Item Name: Crosstube Aft

DART AEROSPACE LTD		Work Order: 85315
Description: Crosstube High Aft (407)		Part Number: D407-667-205
Inspection Dwg: D407-667-245 Rev: F		Page 1 of 1

DRAWING NO. D407-667-245	TITLE CROSSTUBE ASSY (407 HIGH AFT)	REV. F	DART AEROSPACE LTD ENGINEERING ORDER	D.E.O. NO. D407-667-245-F-1	SHEET NO. SHEET 2 OF 2	SCALE NTS
DRAWN	CHECKED <i>UP</i>	MFG. APPR. <i>E</i>	APPROVED <i>W</i>	DE APPR. <i>H</i>		
DATE 11.04.08	DATE 11.04.11	DATE 11.04.12	DATE 11/04/12	DATE 11-04-12

DRAWING NO. D407-667-245	TITLE CROSSTUBE ASS'Y (407 HIGH AFT)	REV. F	DART AEROSPACE LTD ENGINEERING ORDER		D.E.O. NO. D407-667-245-F-2	SHEET NO. SHEET 1 OF 1	SCALE NTS
DRAWN 92	CHECKED ASS	MFG. APPR. E	APPROVED MP		DE APPR. th		
DATE 11.09.07	DATE 11.09.19	DATE 11.09.19	DATE 11.09.19		DATE 11.09.19

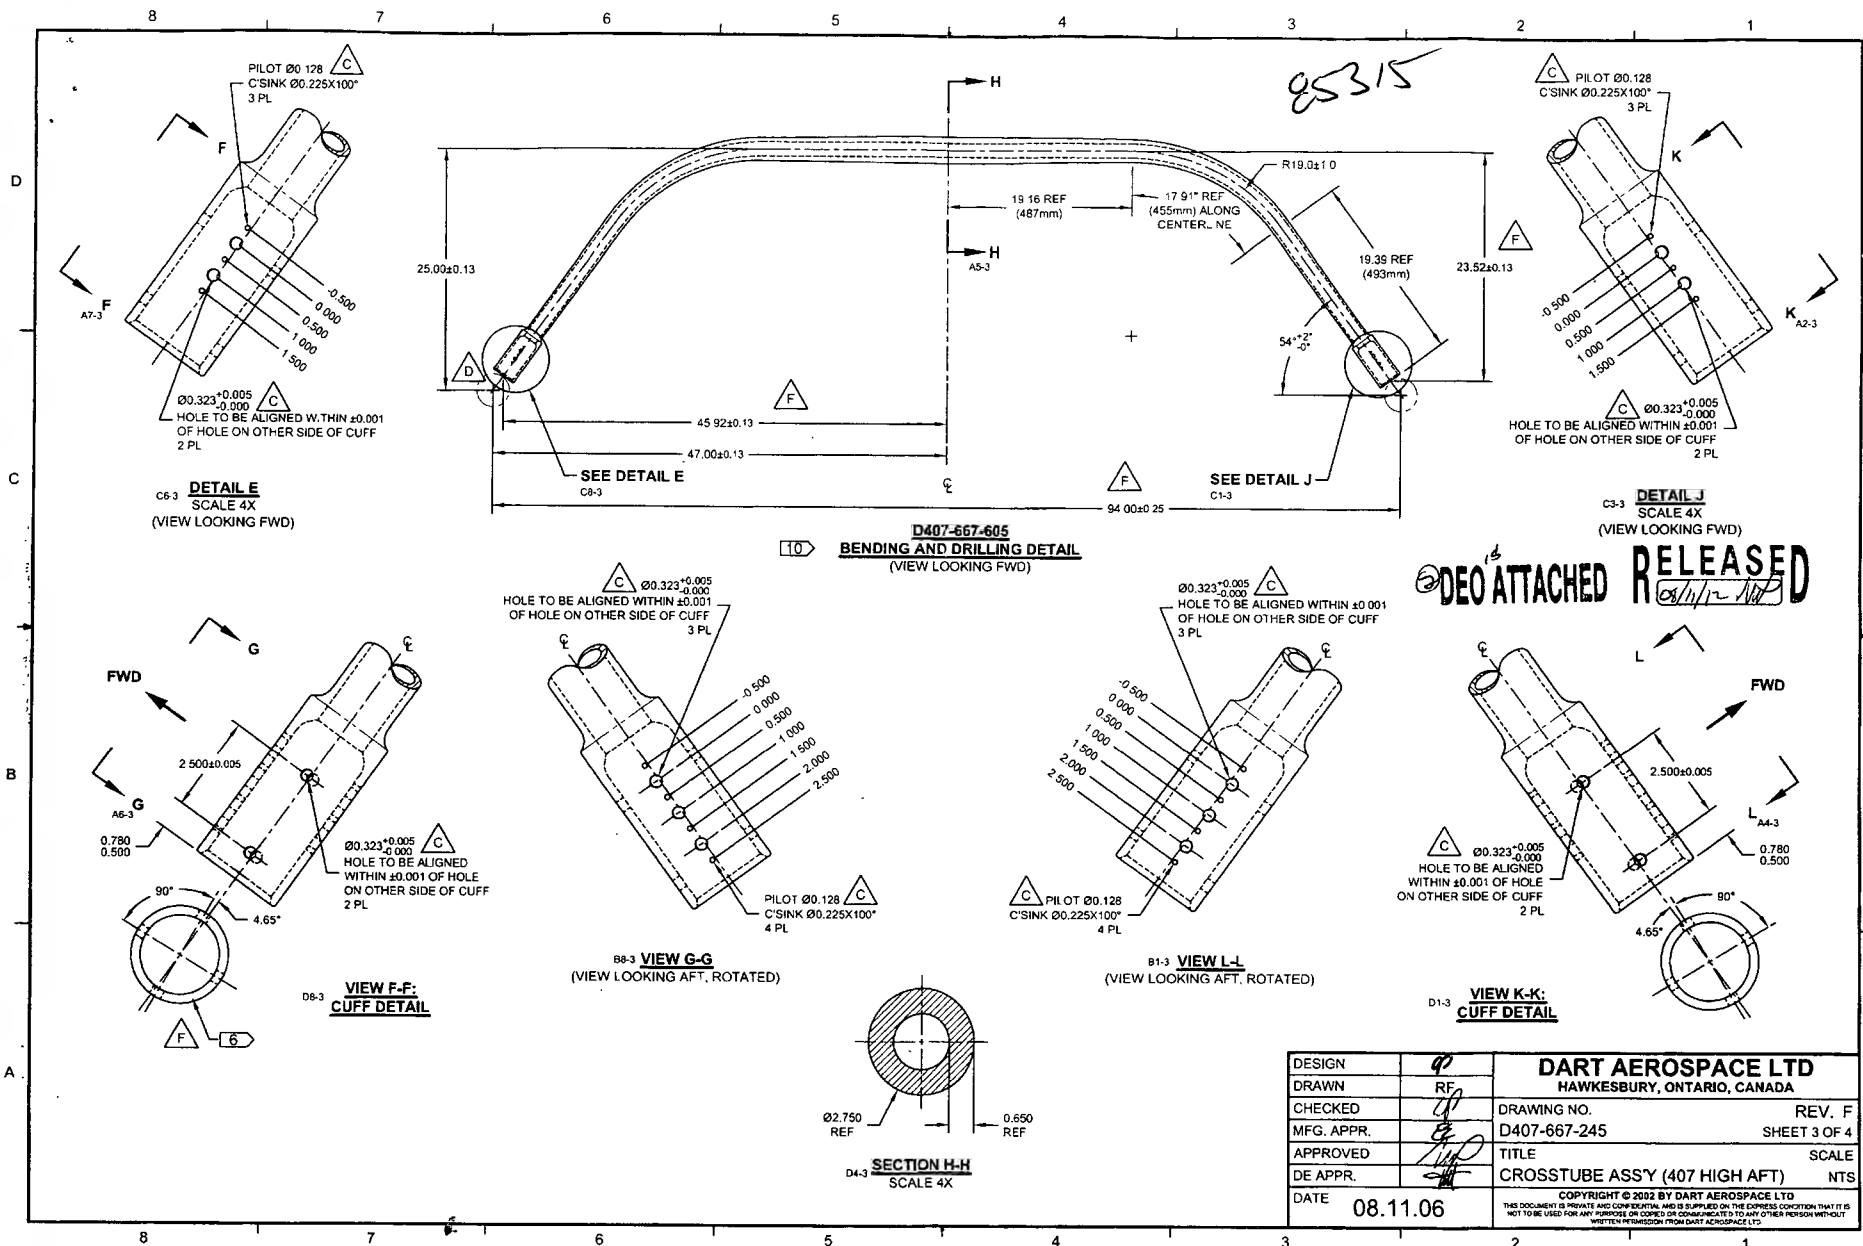
PURPOSE:

REPLACE MAGNOBOND WITH 3M DP460 SCOTCH-WELD EPOXY ADHESIVE

NOTE 12 & 17, SHEET 1 IS AMENDED AS FOLLOWS:

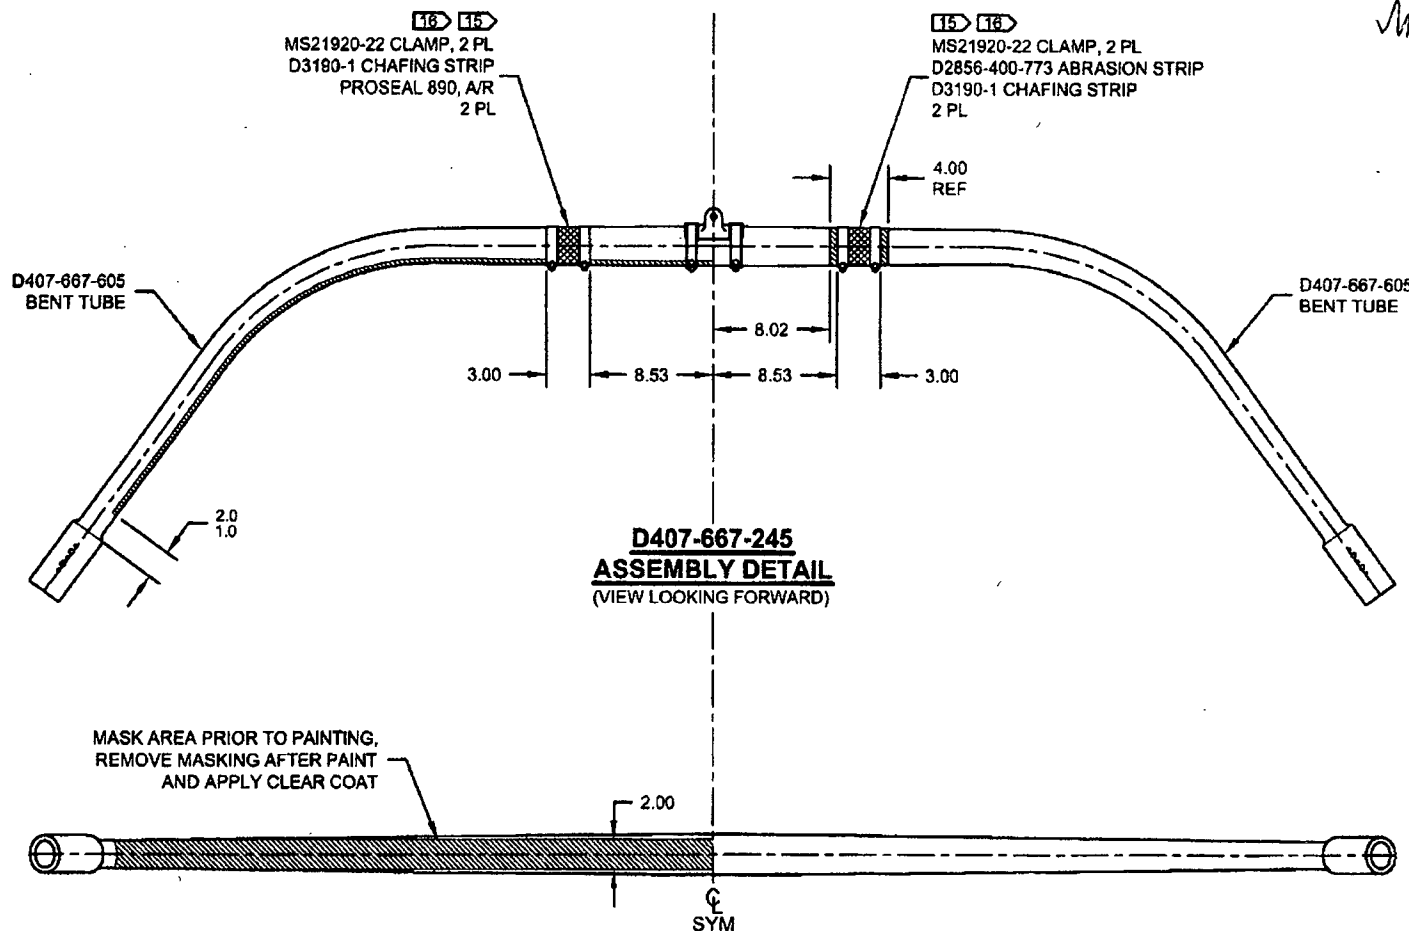
IS:

WAS:
